CABINET MEMBER FOR HIGHWAYS MANAGEMENT – 3 JUNE 2021

DIDCOT – A4130 NORTHERN PERIMETER ROAD EAST OF AVON WAY ROUNDABOUT – PROPOSED TOUCAN CROSSING

Report by Corporate Director, Environment and Place

Annexes Annex 1: Consultation Plan

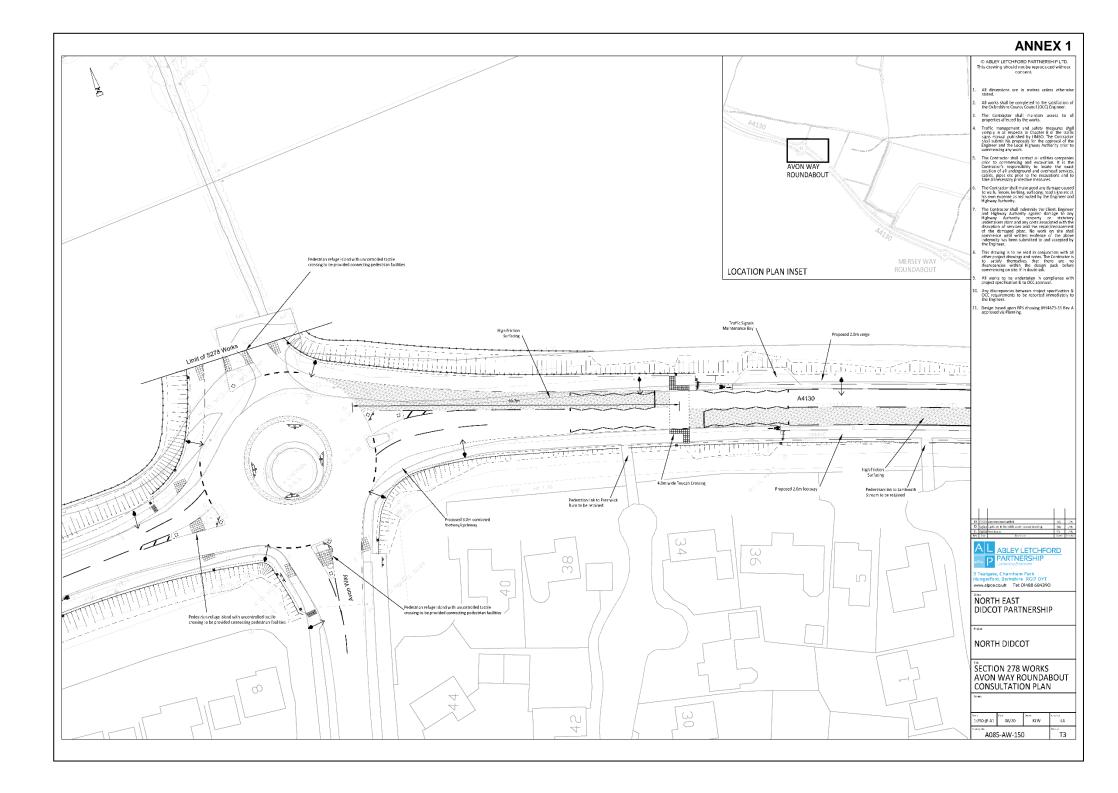
RESPONDENT	COMMENTS
(1) Traffic Management Officer, (Thames Valley Police)	No Objection – In principle I have no objection providing that speed monitoring has taken place which supports a Toucan crossing at this location. And that this crossing meets current design standards. I assume this crossing will eventually lead to future developments as at the moment it will only lead towards open farmland.

(2) South Oxfordshire District Council	Support – The new crossing will link new residential development with Lagygrove providing a safe place to cross on the fast-flowing northern perimeter road.

(3) Local Resident, (Didcot)	Object – "Toucan crossings are noisy and will be right outside our house. Noise from huge amount of traffic is bad enough as it is, we would rather not see increased noise pollution.
	The traffic there is constant and having a stop will mean further queues and accumulation of vehicles many of which are large lorries.
	When traffic will stop at the traffic lights, we will be breathing fumes right outside our house from all the stationary lorries and cars.

(4) Local Resident, (Didcot)	Object – I object to the proposal as this toucan crossing will be directly outside of the front of my house. The houses on this part of Prestwick Burn are some of the closest builds to the roadway. There are houses further up towards Mersey Way roundabout that are built further back and have that buffer. I welcome some kind of traffic calming as the road is extremely fast, busy, and difficult to cross, but I don't wish to have a Toucan crossing with the noise of the alert right outside my windows.

(5) Local Resident, (Didcot)	Concerns – The original proposal was for a footbridge with steps & ramps. This would be a much safer & less disruptive option than a toucan crossing. Traffic control would result in traffic delays, additional engine noise as well as the annoying beeping. With the additional footfall as well as traffic due to the new estate, vehicles & pedestrians need to be better separated.

(6) Local Resident, (Didcot)	Concerns – A crossing is, in principle, a good idea but I have several safety concerns: 1. At present, this road gets used like a racetrack by motorcyclists who all seem to try to hit 70mph+ between the roundabouts meaning they accelerate hard coming off the roundabout heading West (the noise pollution in summer is dreadful), this behaviour means the siting of the crossing poses a danger. 2. The construction of the roundabout is very high meaning that visibility across it is dreadful (for example you cannot see cars' indicators from the far side of the roundabout this has been a concern for a number of years even without the introduction of the proposed crossing) - this poor visibility means that siting a crossing this close to the roundabout possess a danger to users. 3. This is a very busy road, siting a crossing here means that traffic will regularly back up on to the roundabout causing additional congestion and risk, especially to cyclists trying to co-exist with motorists on what is already a risky stretch of road for cyclists. 4. The siting of the crossing will encourage a large amount of foot traffic to cut through into Prestwick Burn which doesn't have any foot paths at the northern end posing additional risk to pedestrians. 5. Additional cyclist traffic also cutting through Prestwick Burn would also pose extra risk due to several sharp bends in Prestwick Burn with very poor visibility. A safer site to consider would be a few hundred yards to the west (location: 51.617919,-1.233244) which doesn't have the issue of being close to a roundabout and has the additional advantage of linking to an existing public footpath through the Ladygrove estate. If a crossing is placed on this stretch of road (in either location), at minimum I would expect to see work to lower the

height of the roundabout and traffic speed safety cameras installed in the middle of the stretch of road between the roundabouts to the west of the Avon way junction.

With the increased urbanisation of the A4130 through N. Didcot I would also recommend a reduction in the speed limit throughout the whole of the section of this road where it is currently set at 50 mph.

(7) Local Resident, (Didcot)	Concerns – Considerations should be given to making the section of the A4130 that runs behind the Ladygrove Estate (between the Ladygrove estate and the new development at Willowbrook) a 30mph speed limit area (noting that the current speed limit is 50mph). At the very least the area 150-200meters on either side of the proposed toucan crossing. Some traffic does travel along this stretch of road at significant speed. Given that this section of road will be before long cutting through the middle of two significantly large housing estates a reduction of the speed limit now may save re-looking at this when the Willowbrook estate has been completed.] when such a speed limit (50mph) will likely cause significant issues to people and traffic transiting from one estate to the other.

(8) Local Resident, (Didcot)	Concerns – Although I do not initially have any concerns with the installation of this crossing, I wonder if you could clarify the following: 1. Will the speed restrictions along A4130 be reduced? If so, will this be the entire length of the road or just by the crossing? What is the intended speed limit? and will there be speed cameras installed? This road is considerably busy and sadly the majority of traffic tends to travel at a higher speed than allowed. I think it is currently 50mph but would welcome a lower limit. 2. Regarding the plans to widen the current footpath to 2m. Can you confirm that the current trees and bushes along the edges will not be affected? Currently the hedgerows block out a considerable amount of traffic noise level to our property and removing them would cause more of a problem.

11. A noise survey has been undertaken which concluded that the anticipated noise levels will not be excessive taking account relevant national regulations.

12. The toucan crossing is located sufficiently away from the roundabout to prevent any backing up onto the roundabout.

13. The location of the toucan crossing is best situated when considering pedestrian/cyclist desire lines and highway safety. The crossing is intended to provide a vital pedestrian/cyclist link between Didcot and the new housing development. The roundabout improvements and toucan crossing have been subject to an independent safety review. There are no safety concerns which were raised by that review that have not been resolved in the current design. The approved planning documents and s106 agreement does not refer to a footbridge over the A4130, instead toucan crossings are approved to safely allow pedestrians and cyclists to crossing the A4130.

14. As part of the approved works for the Avon Way roundabout the height of the roundabout is being reduced and like the works that have been recently completed on the Mersey Way roundabout this will improve the visibility across the roundabout.

15. The pedestrian link from the A4130 into Prestwick Burn joins at the end of a turning head for 5 properties and where Prestwick Burn continues south west a footway is provided for use by pedestrians; given the very low vehicles movements the existing shared surface is suitable for pedestrians to use.

16. All the highway works associated with the development including the Toucan Crossing have been designed in accordance to the required standards for the current speed limit and speeds on the road. In respect of the request for speed cameras, while accepting that achieving better compliance is in principle very desirable, the provision of speed cameras is outside the scope of this scheme.
